City of El Paso – City Plan Commission Staff Report

Case No: SULD13-00001 Sierra Del Puerte
Application Type: Land Study
CPC Hearing Date: February 12, 2015
Staff Planner: Nelson Ortiz, (915) 212-1606, ortiznx@elpasotexas.gov
Location: North of Titanic and West of Magnetic
Acreage: 175.45 acres
Rep District: 4
Existing Use: Vacant
Existing Zoning: PMD (Planned mountain development) and P-R-1 (Planned residential I)
Proposed Zoning: PMD (Planned mountain development) and P-R-1 (Planned residential I)
Nearest Park: Sunrise Park (.49 mile)
Nearest School: Canyon Hills Middle (.85 mile)
Park Fees Required: N/A
Impact Fee Area: N/A
Property Owner: Daniel T. Knapp, Palo Verde Properties, LP and GCGOHL, LLC
Applicant: Daniel T. Knapp, Palo Verde Properties, LP and GCGOHL, LLC
Representative: Roe Engineering, L.C.

SIERRA DEL PUERTE LAND STUDY

ATTACHMENT 3

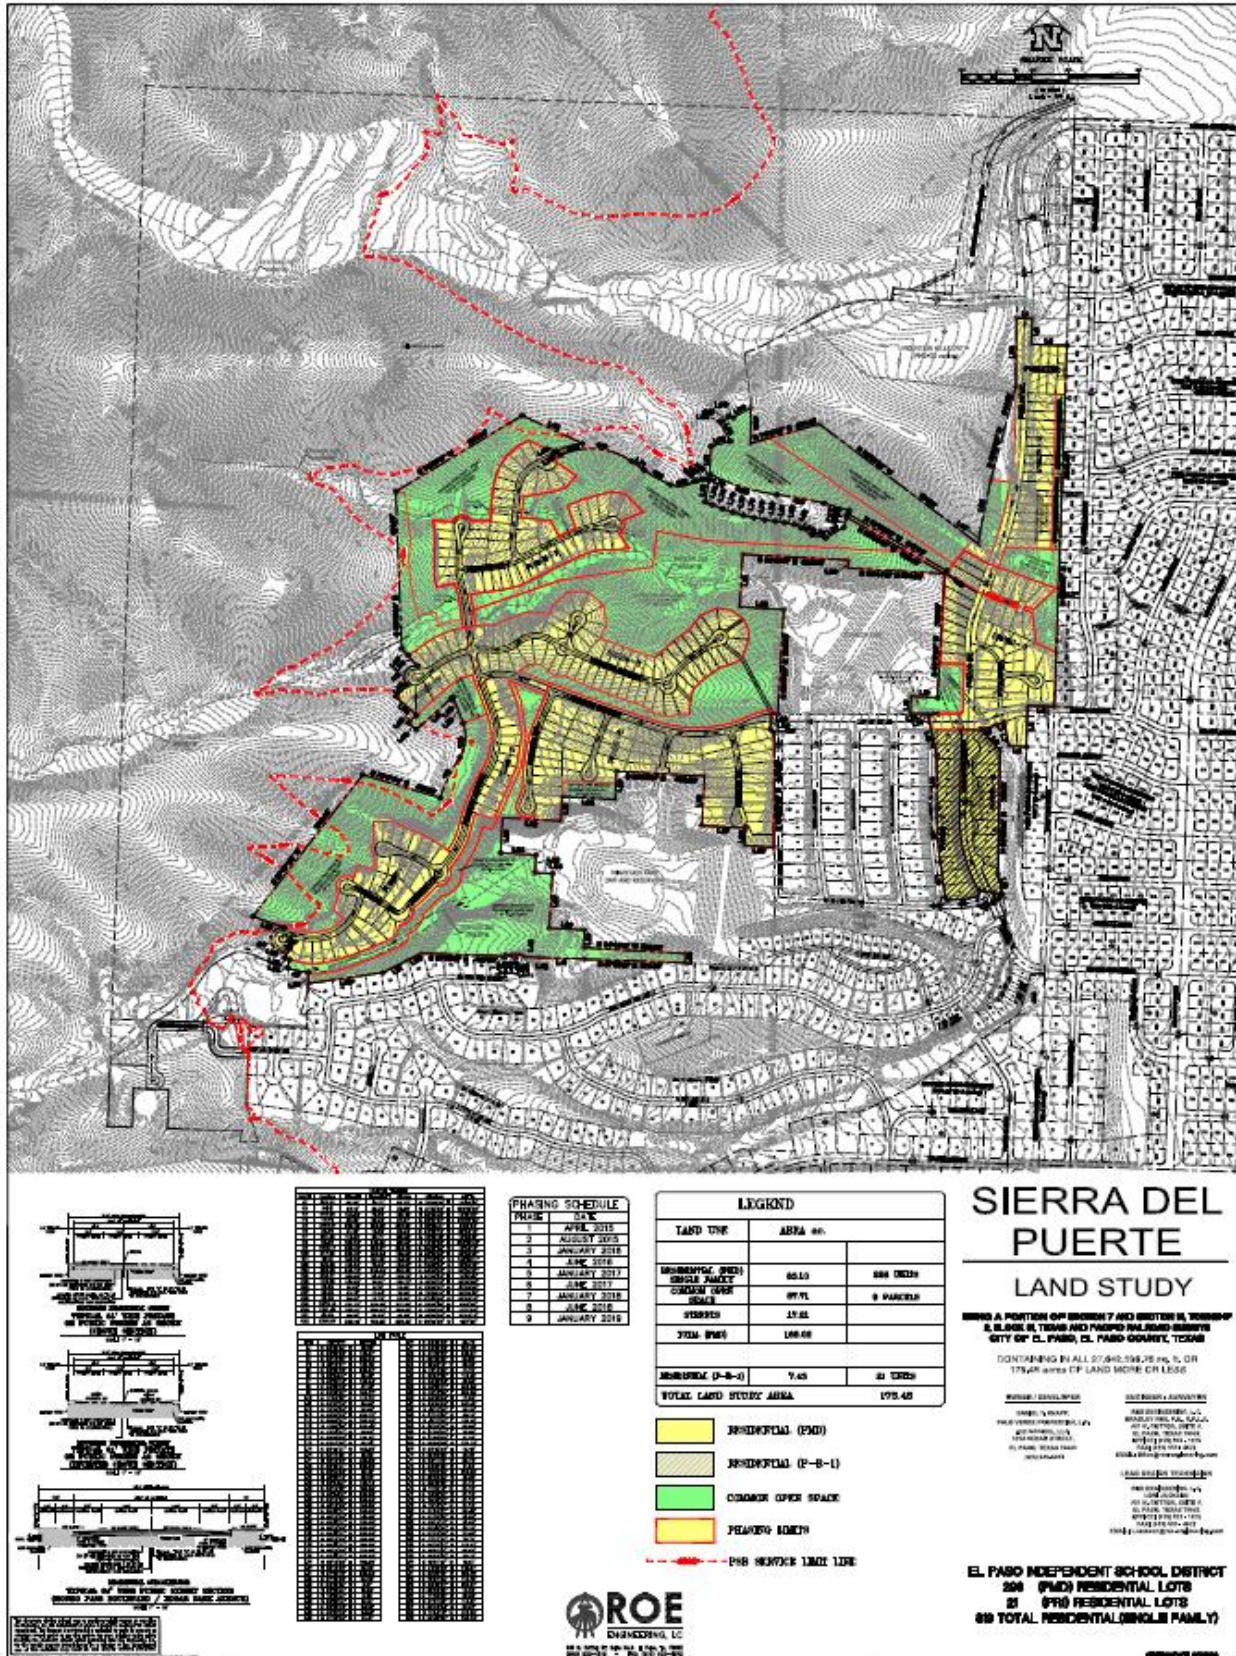
1. The development is located within an existing natural arroyo. Applicant shall comply with the requirements of Preservation of Natural Arroyos (Section 19.19.010.F).
2. EPWU also requires drainage rights-of-ways in lieu of any proposed drainage easements.
3. Sunrise Dam & Mountain Park Dam are USACE structures therefore any and all proposed subdivision improvement plans must be coordinated and approved by USACE through EPWU Storm-water Operations Manager prior to final City approval (See Attachment #3 & 4).

1. Clarify if the portion of the "Proposed Channel" from the southwest corner of this development to the limits of the Franklin Mountains area is to be constructed /included in this development; where possible, arroyo paths should be left in its natural state/undisturbed.

2. A trailhead / Hike & Bike trail needs to be discussed /coordinated with the Parks Open Space Coordinator (Marcia J. Tuck) for a connection from the southwest corner of this development along the proposed channel to the limits of the Franklin Mountains area - Park's Open Space coordinator will coordinate location of the trailhead with the Franklin Mountain State Park ranger.

3. Label all "Common Open Space" areas as "Private" and clarify the maintenance responsible party.
4. Parks Department previously had requested from the Developer to identify all existing trails with-in this development as well as adjacent trails with-in the Franklin Mountains and the Castner Range areas and as per meeting on April 18, 2013, Developer stated that there were no trails only some graded access.

1. Water service can only be provided to Lots with finished floor elevations up to 4550 feet (PSB datum).
 - a) Extend the Proposed 20' PSB easement to tie into Gunnison Dr.
 - b) Due to TCEQ regulations, EPWU discourages the installation of dead end mains. Two 8-inch diameter water main extensions along all cul-da-sacs will be required to loop the water system.

- c) A water main extension will be required to serve the Phases 3, 6, 7, 8, and 9 from Zircon Dr.
 - d) Another water main extension will be required along Edgar Park Avenue to Virgo Lane.

- e) Owner/Developer is responsible for all water extension costs.
2. Sanitary sewer is critical for portions of the development. EPWU cannot commit to providing sewer service to the entire land study area until further review of the grading plans.

- a) A sanitary sewer extension will also be necessary to connect to the existing sanitary sewer system at Zircon Dr. to provide service for Phases 3, 6, 7, 8, and 9.

- b) A 25 foot PSB easement will be required for the sanitary sewer extension along the common open space between phase 6 and Zircon Dr.
 - c) A lift station along with associated force main will be required to provide service for Phase 7.

- d) Owner/Developer is responsible for all sanitary sewer extension costs.
